Campbell's Cove

Deletion of Stage 4 Ports Authority Works

SYDNEY HARBOUR PROMENADE DESIGN RESPONSE TO SUBMISSIONS

NOVEMBER 2017

Fig. 9: Concept Plan

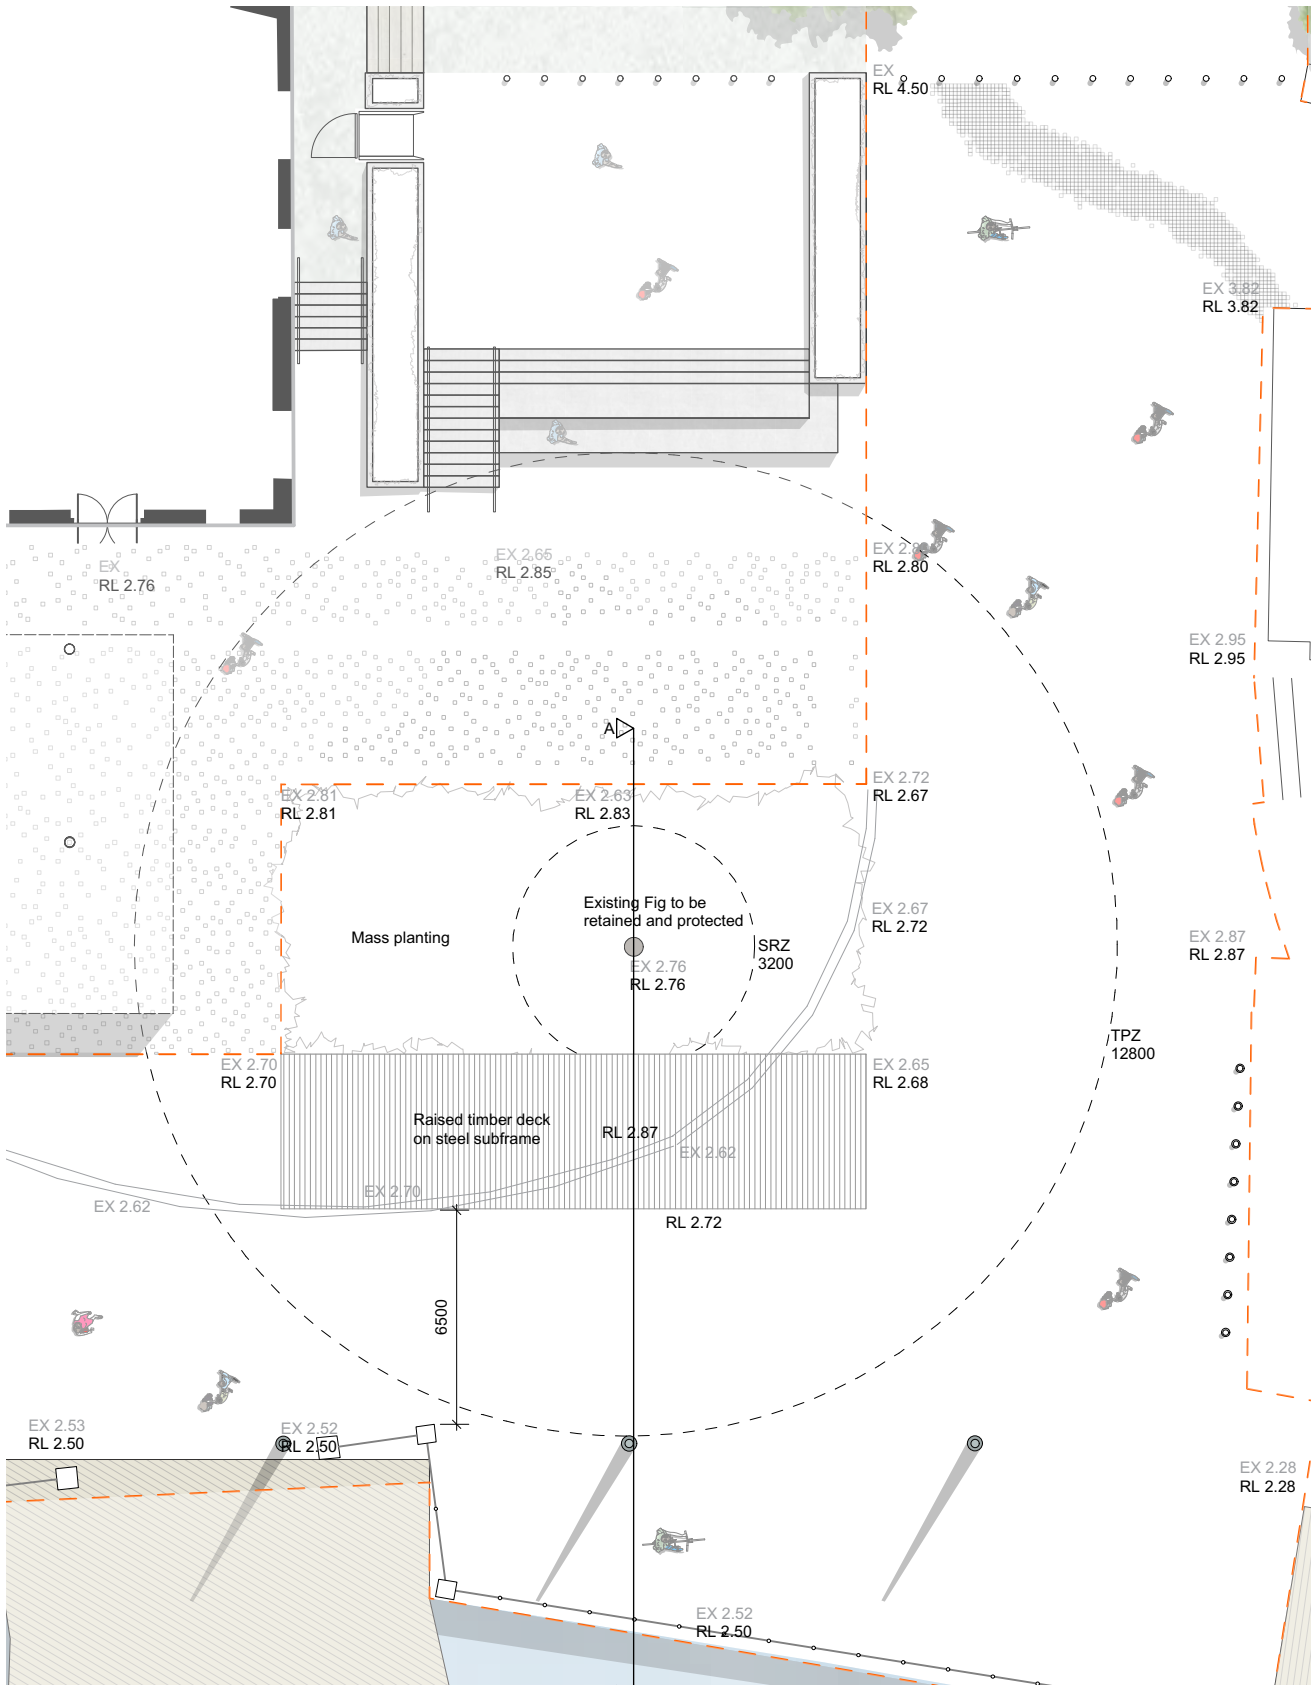
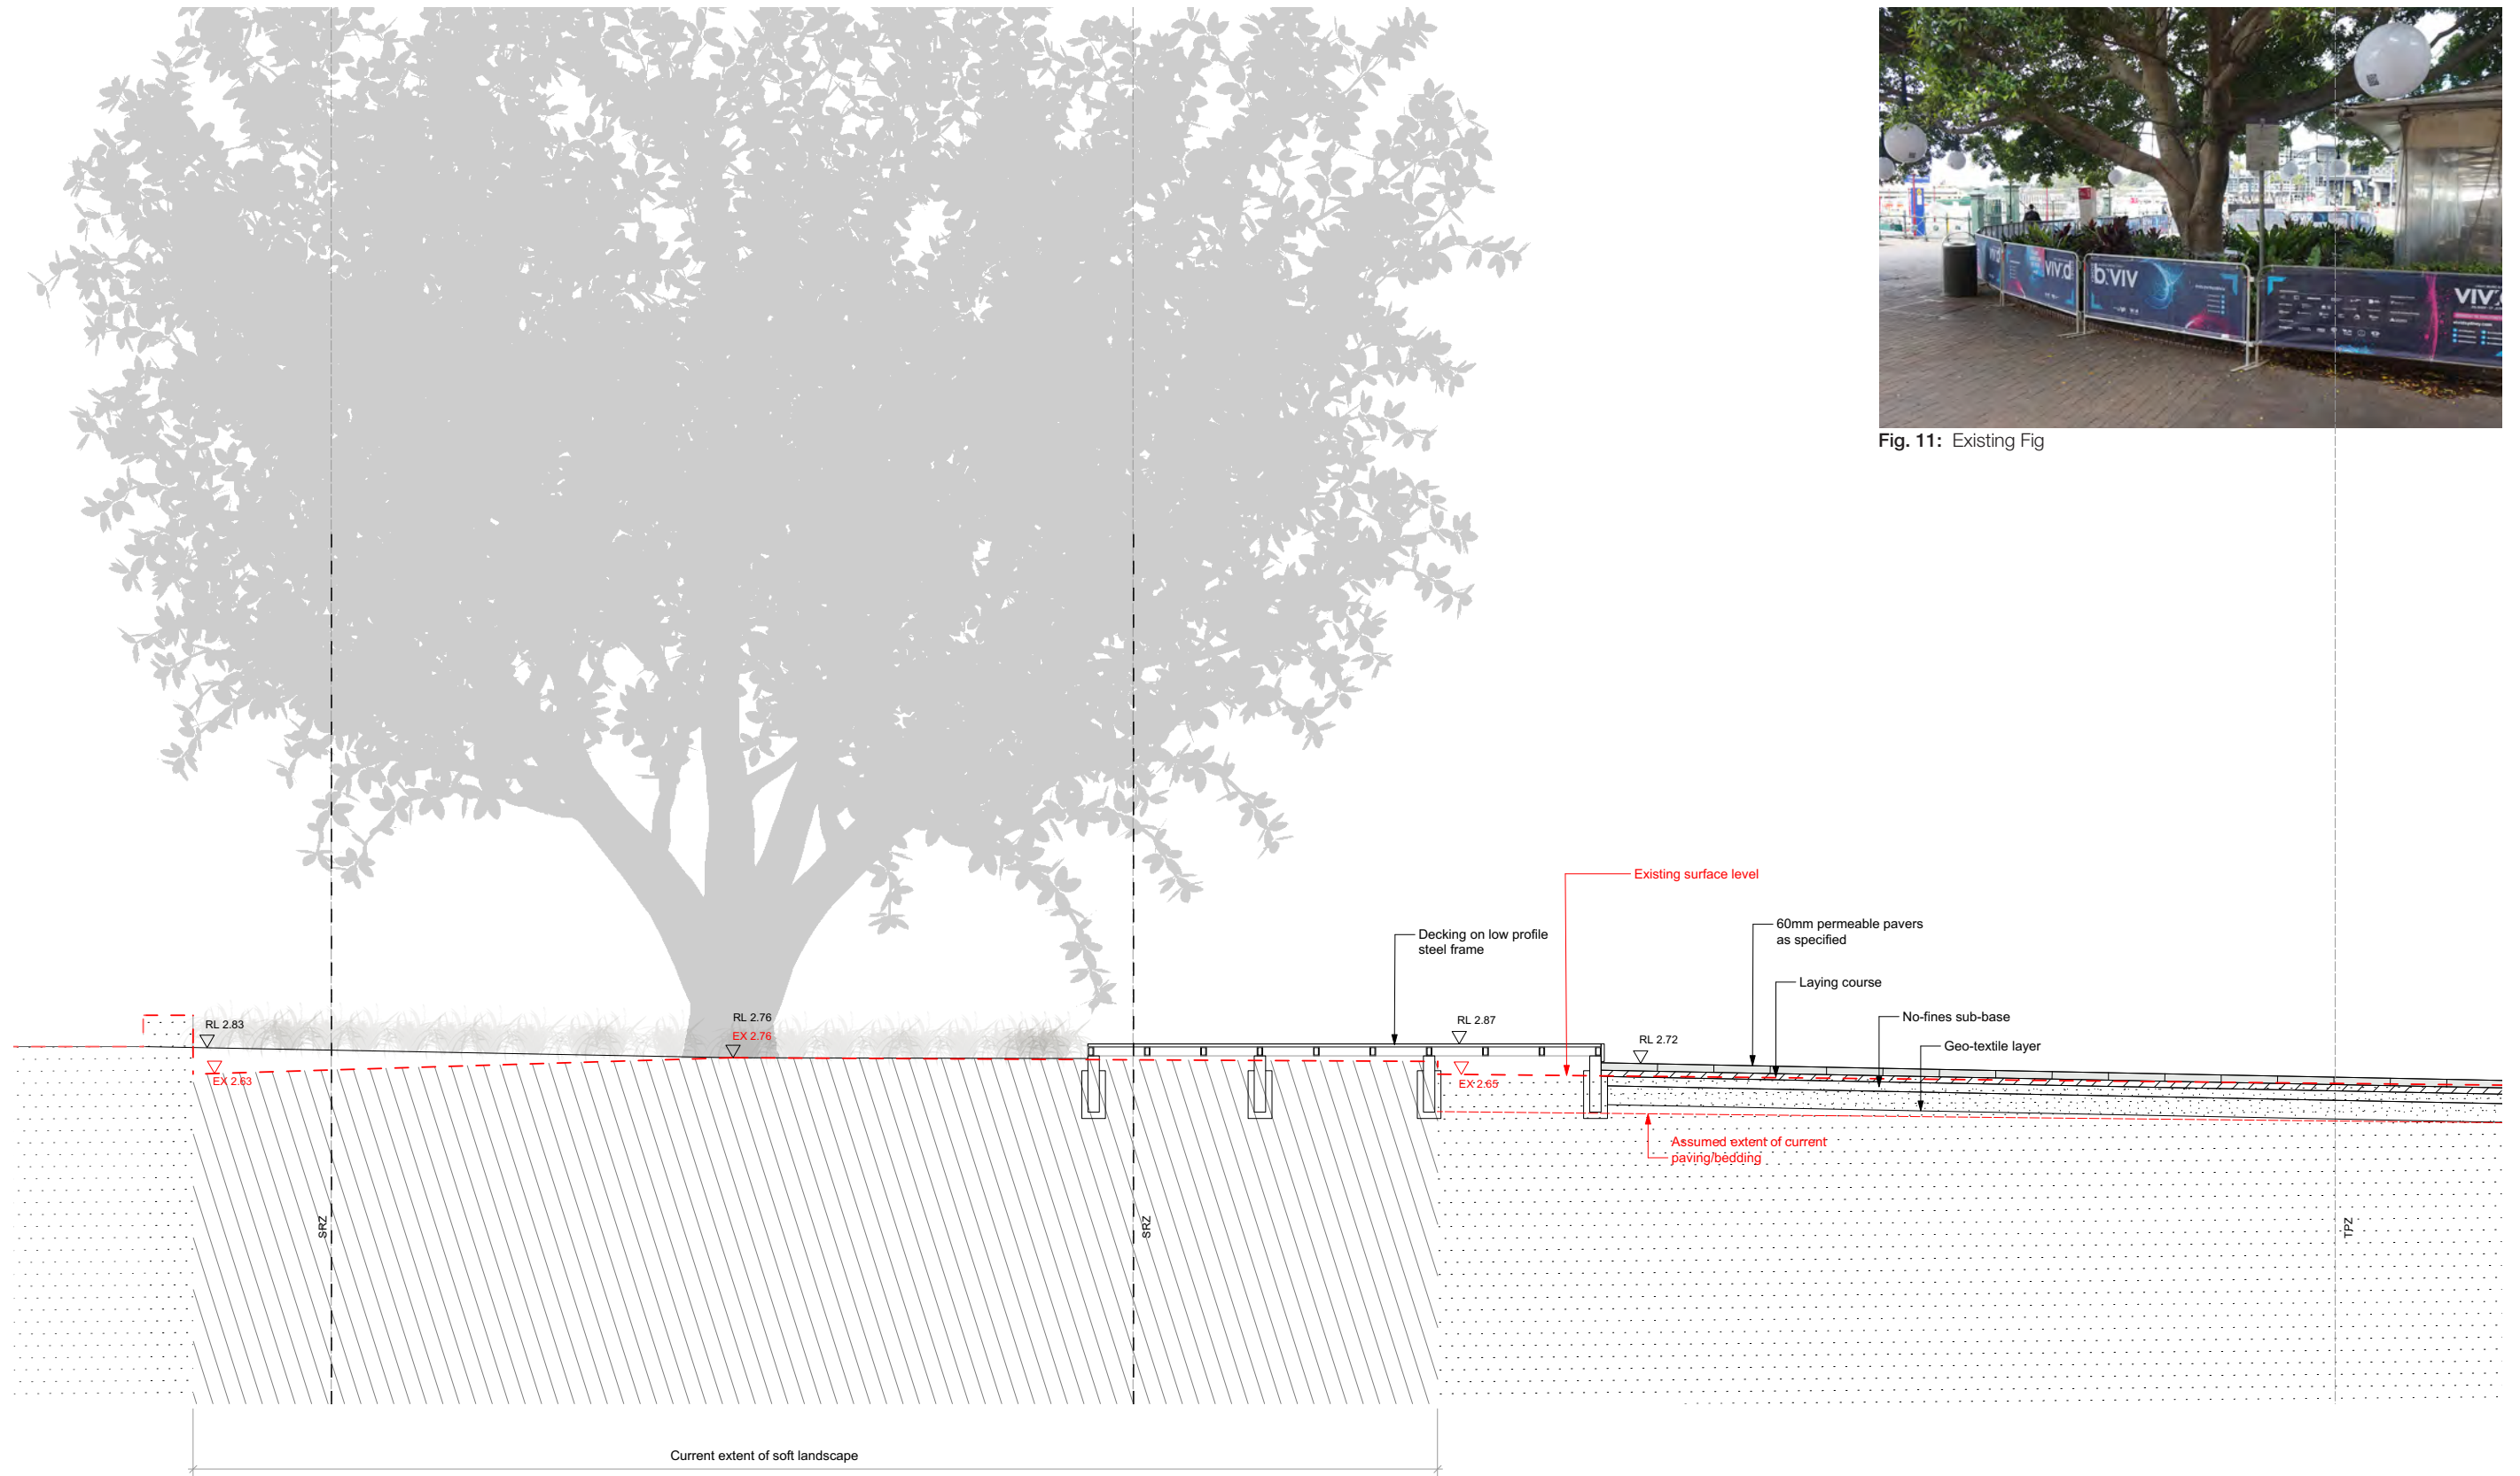
“.....modifications to the garden and grassed area within the 13 metre TPZ for the purpose of footpath widening is not supported”

Care has been taken in the design response to ensure no reduction in levels within the TPZ of the existing Fig. Where possible, paving levels have been raised to remove the need for excavation below the existing sub-grade layer.

In the area immediately to the East of the existing Fig, the existing garden bed is to be replaced with a timber deck on lightweight steel subframe to further protect the tree's root system.

- Existing pavement – Brick pavers 75 and 80mm thick with fill comprising silty sand.
- Proposed pavement – 60mm permeable paving over 30mm no-fines sub base.
- Permeable pavement extends beyond the 12.8 metre TPZ as detailed in figure 9
- Raised timber deck on low profile steel subframe to current soft landscape area as detailed in figure 10

Fig. 16: Proposed Design

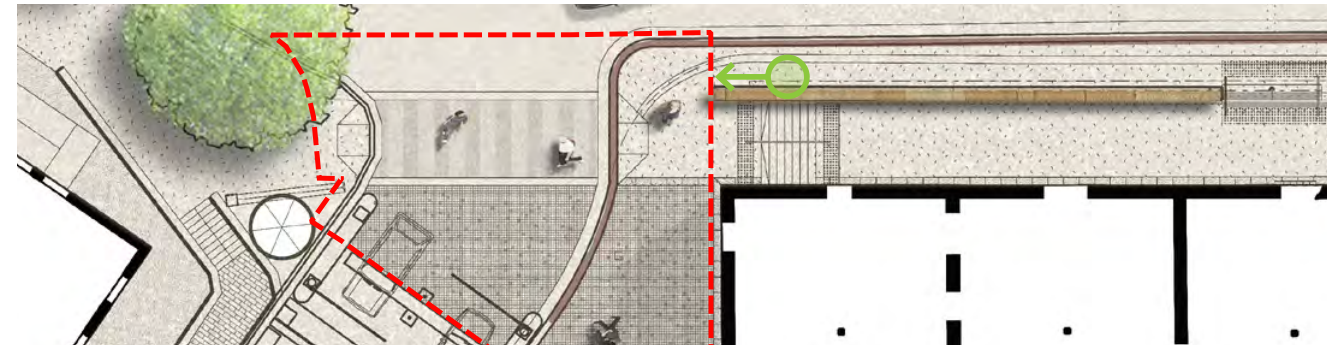
"The City would prefer vehicular access to be redesigned to give priority to pedestrians and cyclists. This can be achieved by continuing the type of footpath material and grade (i.e. continuous footpath pavement)" City of Sydney submission.

This option raises the junction between Hickson Road and the Overseas passenger terminal. The raising of the junction eliminates existing speed humps as the entire threshold is raised. In addition, pram ramps have been eliminated and thus allows pedestrians and cyclists to utilize the full width of footpath to cross the threshold.

This option maintains the existing grade of the vehicle crossing and therefore pram ramps and speed humps are required. The change in materiality is used as noted above. However, we feel that while this option reduces the vehicular dominance of the junction, it stops short of shifting the priority to pedestrians/cyclists.

Fig. 22: Proposed Design promenade paving modules

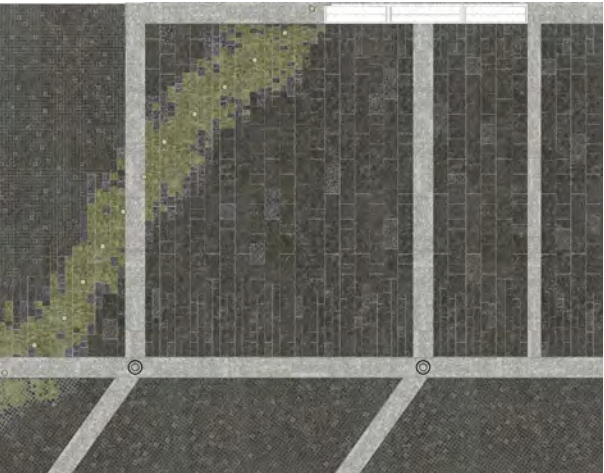
"The City recommends that consideration be given to simplifying the design to better unify the space. Consideration should also be given to replacing the concrete boardwalk with timber to unify the edge of the cove".

"It is recommended that the interpretive shoreline paving detail should be deleted and replaced with bronze inlays, as currently exists in Circular Quay East."

Taking these comments into consideration, Context's design response provides a simplified paving pattern in line with the Circular Quay Public Domain Manual, in a dark colour with 30% light coloured inflections in 'Austral Verde' and 'Juparana'. The pavement design utilizes the austral black granite paver arranged in the standard City of Sydney arrangement as the body paver unit. A variety of finish types in conjunction with the 30% contrast will give a level of diversity and complexity to the pavement design and help to unify the overall pavement treatment of the site.

- Simplify paving pattern and comply with the Circular Quay Public Domain Manual
- Use Granite with grey tones near shoreline with inflections of sandstone shades towards Campbell's Stores
- Bronze inlays are currently included in the shoreline pattern.
- If the Shoreline paving detail is undertaken as part of the Campbell's stores upgrade, then it should be completed as part of the Campbell's Cove upgrade

Fig. 26: Proposed section showing existing ground level in red.

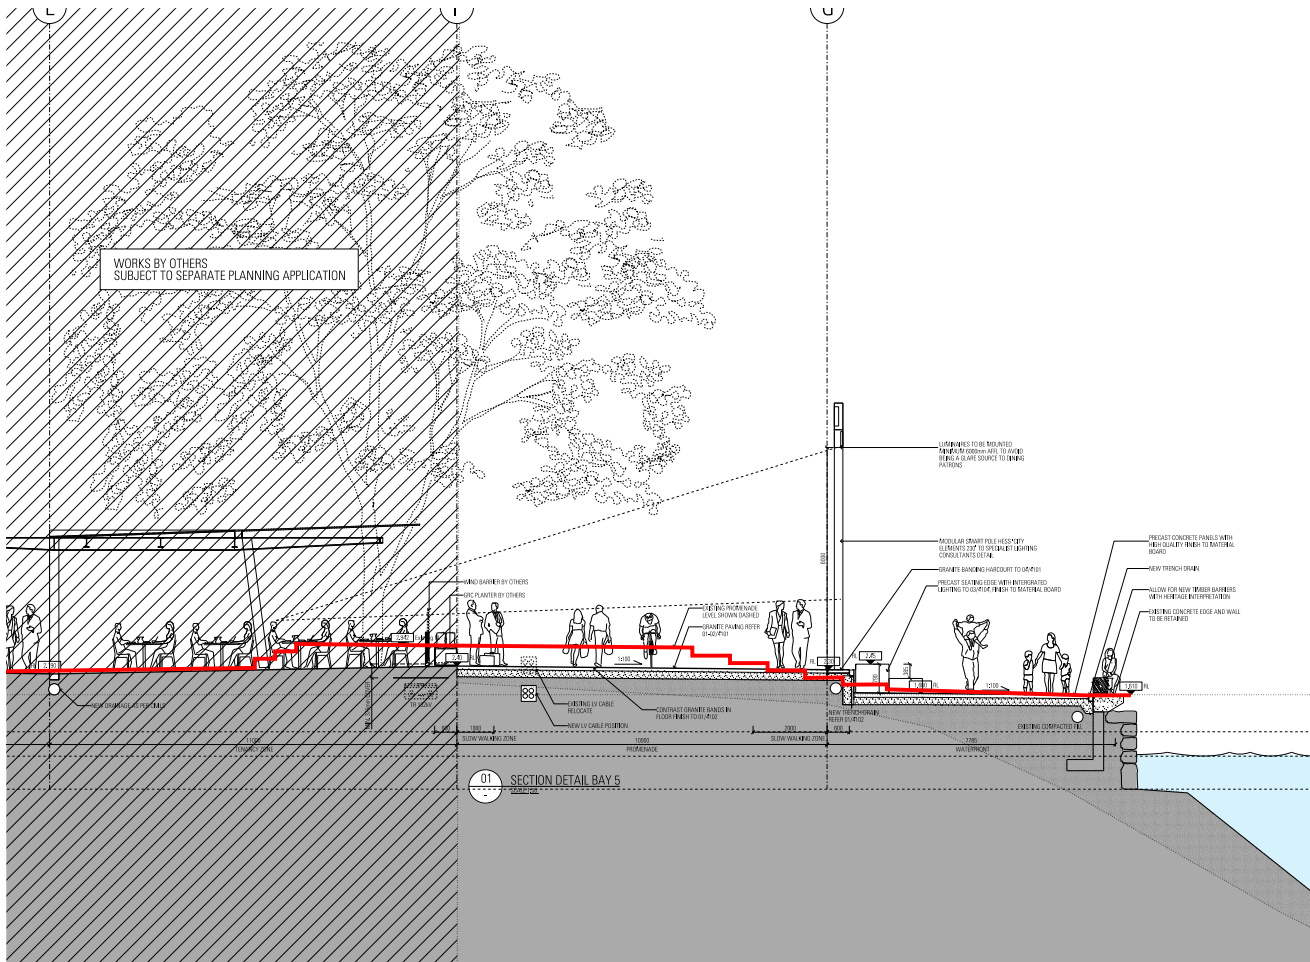
"It is recommended that the proposed levels be reconsidered, and consideration be given to future proofing the site from projected sea level rise."

The existing floor levels in the stores are below RL 2m AHD for several floors. We have designed a non-return valve to be included in the stormwater system for discharge to the harbour

The sea level rise projection for 2100 for Sydney Harbour is RL 2.28m AHD, up from RL 1.44m AHD in 2010 and RL 1.78m AHD in 2050.

The crest from the harbour to the stores building is reduced but it is still above the 2100 projected level guide at RL 2.40m AHD.

Fig. 28: Proposed Campbell's Stores stairs - PTW - Tables and chairs to be removed from area shown in green

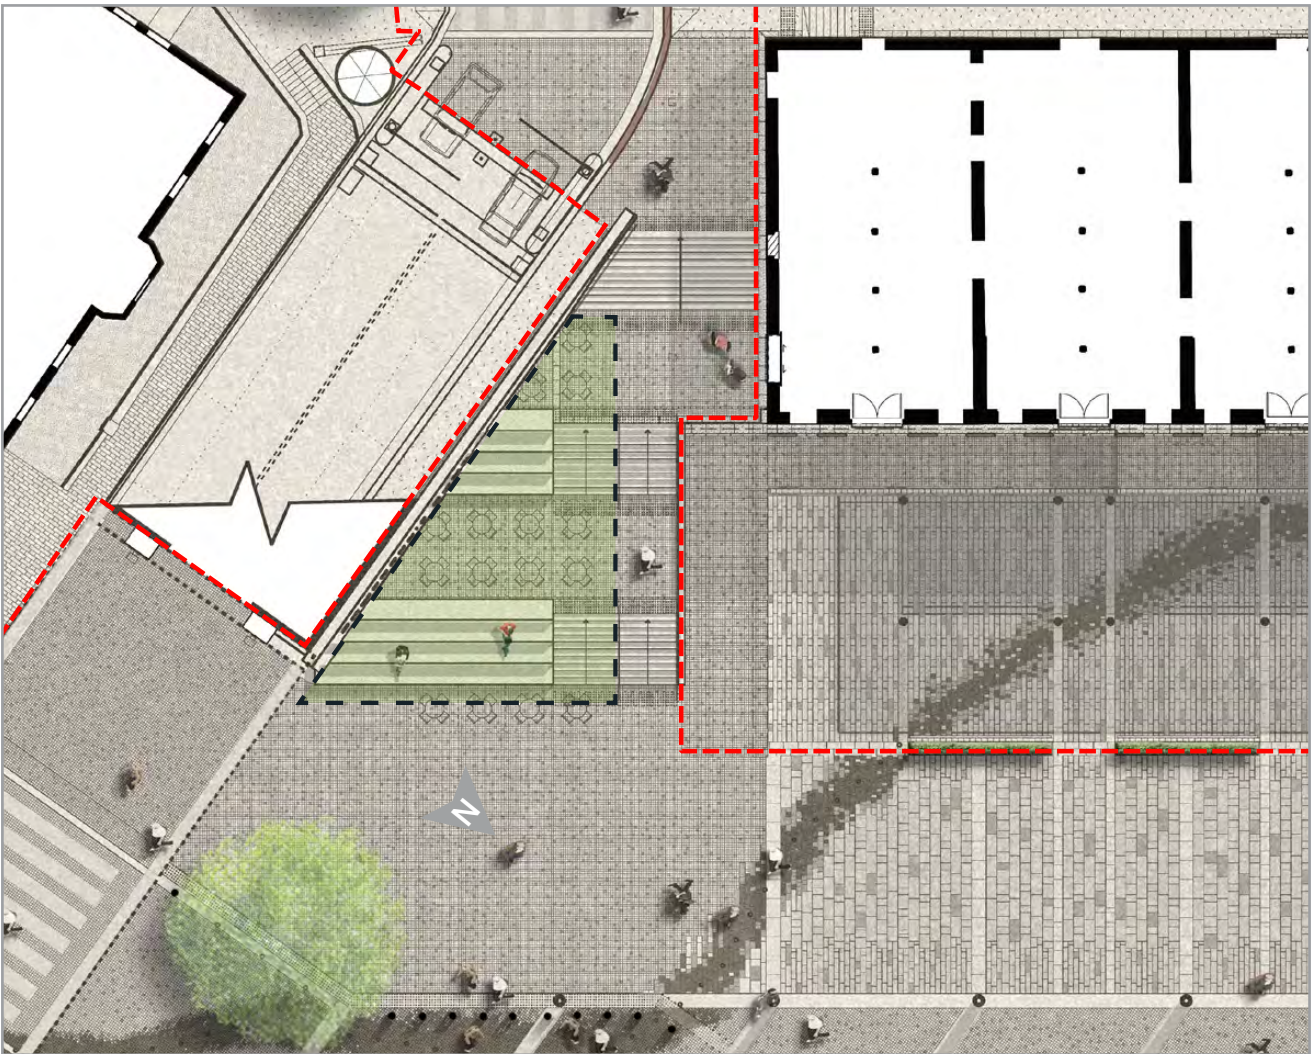
"Tables and chairs positioned between the main stair rises are clearly inappropriate and must be deleted from the plans to ensure pedestrian flows are not encumbered in any way."

The leaseable area of seating located in alignment with the proposed stairway (highlighted green in the adjacent plan) has been deleted from the concept plan.

- Remove tables and chairs from area outlined in green (refer fig. 28)
